**2<sup>nd</sup> Further Information**

**Proposed Temporary Warehouse (Excluding Dangerous Goods Godown) with Ancillary Facilities  
and Associated Filling of Land and Pond for a Period of 3 Years in "Agriculture" Zone,  
Various Lots in D.D. 107 and Adjoining Government Land, Kam Tin, Yuen Long, N.T.**

**(S.16 Planning Application No. A/YL-KTN/1180)**

**Response to Comment**

Drawing No. W1010/112 Stage P Rev. A

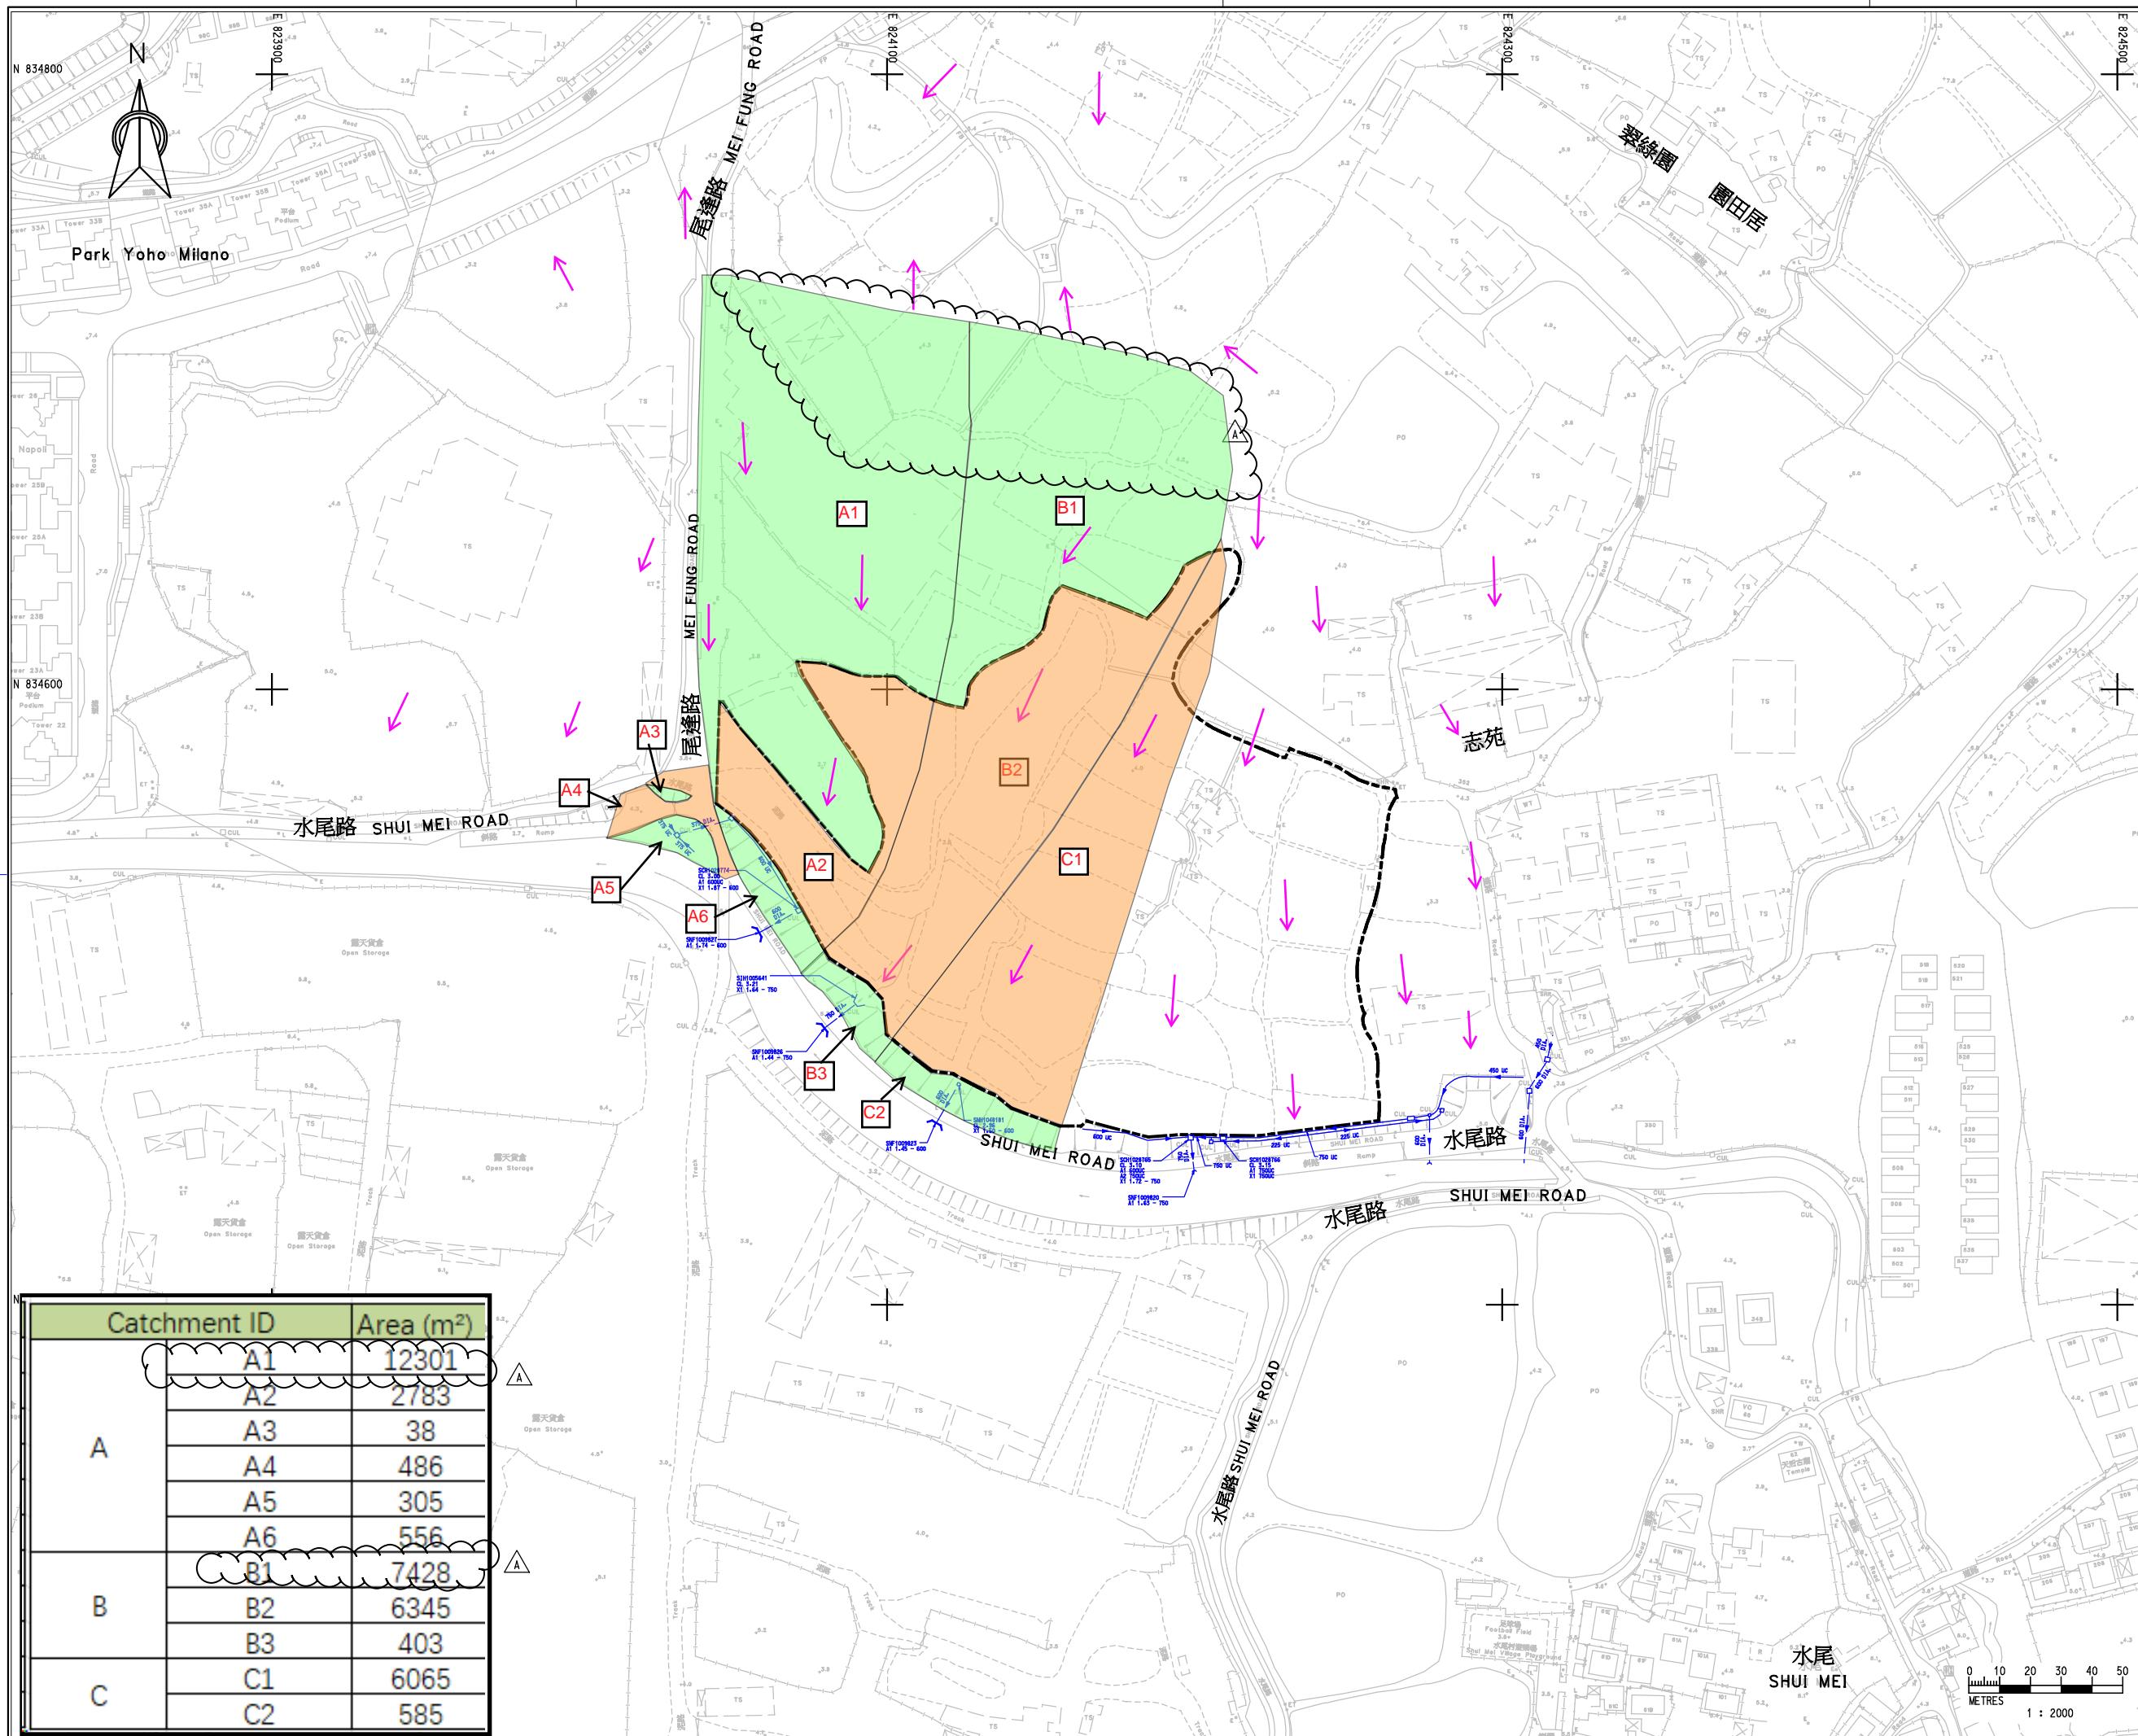
| Departmental Comments   | Applicant's Responses   |
|---|---|
| <p>(2) Cross sections showing the proposed drainage facilities and existing and proposed ground levels of the captioned site with respect to the adjacent areas should be given. Some information is missing in the submitted cross sections. Also, the applicant should clarify discrepancy of the proposed surface channels shown in the submitted drainage plan and Section C.</p> | <p>The cross sections in drawing no. W1010/112 have been revised to show the proposed drainage facilities along with the existing and future ground levels of the captioned site with respect to the adjacent areas.</p> <p>The surface channel presented in Section C has been deleted to be consistent with the proposed drainage plan.</p>   |

**Drawing No.** W1010/115 **Stage** P **Rev.** A

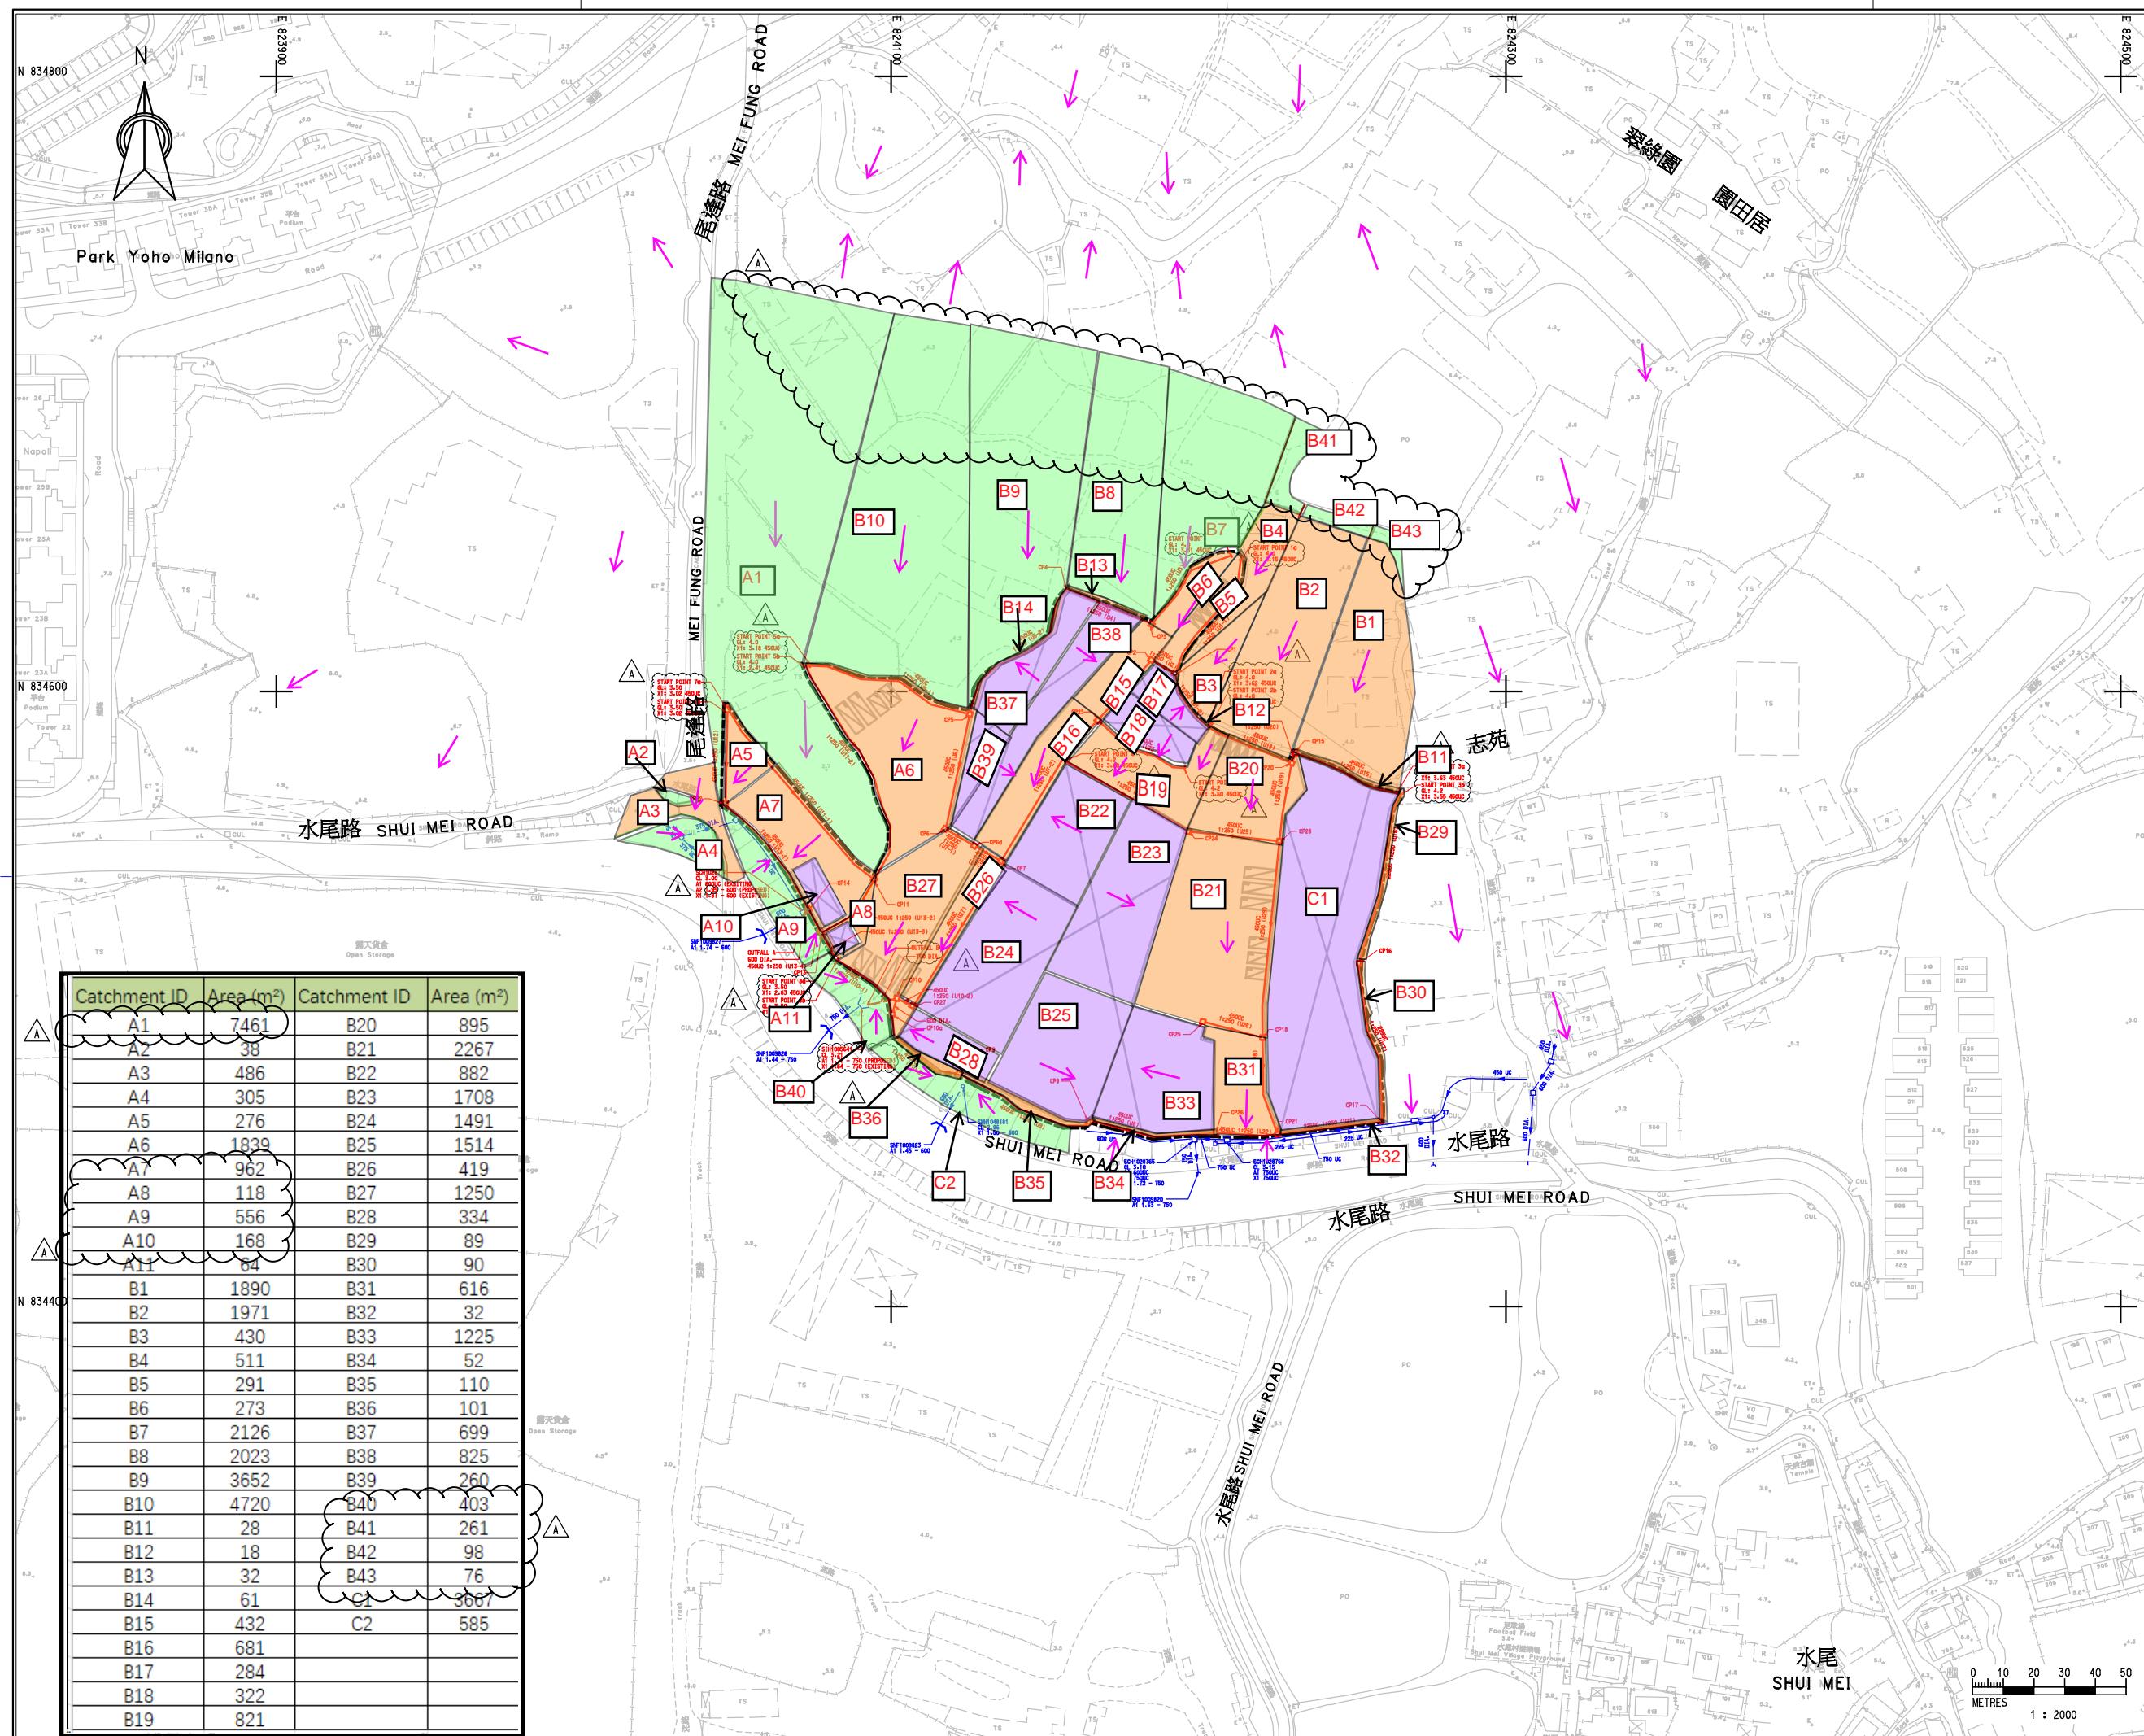
| Departmental Comments   | Applicant's Responses   |
|---|---|
| <p>(1) The ground to the north and northeast of the application site is generally higher. According to the topography around the subject site, external catchment area shall be greater than the one adopted in the submitted hydraulic calculation. The applicant should update hydraulic calculation.</p>   | <p>A revised drainage impact assessment (DIA) is provided by the applicant to review the drainage arrangement for the proposed development (<b>Annex III</b>).</p> <p>We have further expanded the catchment area in this study to cope with the site at the north and northeast of the project site based on the available topographic information.</p> <p>The corresponding hydraulic calculation in Appendix B has been also updated based on this revised catchment area, which is shown in the drawing nos. W1010/115 &amp; 116.</p> |
